2 - 96 Bathurst Street, Hull

Type 3 Fire Risk Assessment

Prepared for:	Rebecca Franks, Building Safety Manager
Prepared by:	John Askew, Fire Risk Assessor, Holistic Fire Safety
Date:	29/10/2025
Document Reference:	HFS.HCC.BathurstStreet2.FRA.3.0

Photo 21

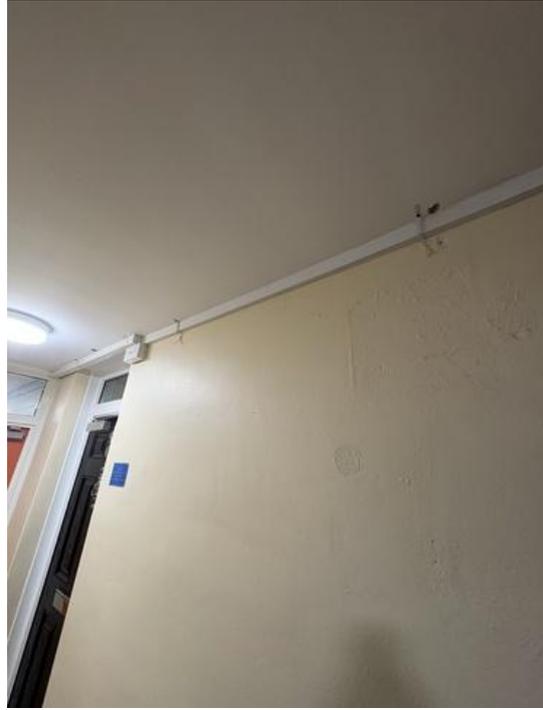
The majority of service cables that traverse along escape routes within conduit are adequately supported by metal connections, which prevent them from drooping or falling in the event of fire. However, service cables leading to the Pump Room were noted to be secured with plastic tie wraps or not secured at all.

Secure service cables with metal clips appropriate distances apart.

Photo 61

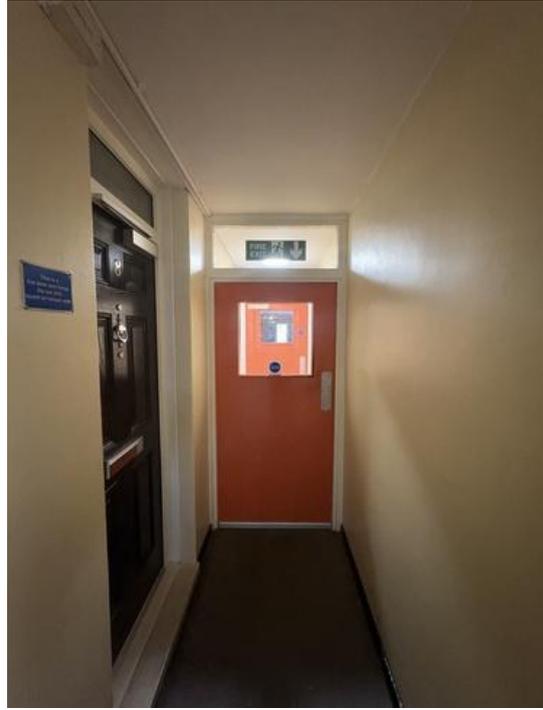
The Georgian wired glass top-light to the corridor door near flat 72 was damaged and requires replacing.

Replace damaged Georgian wired glass top-light to the corridor door near flat 72.
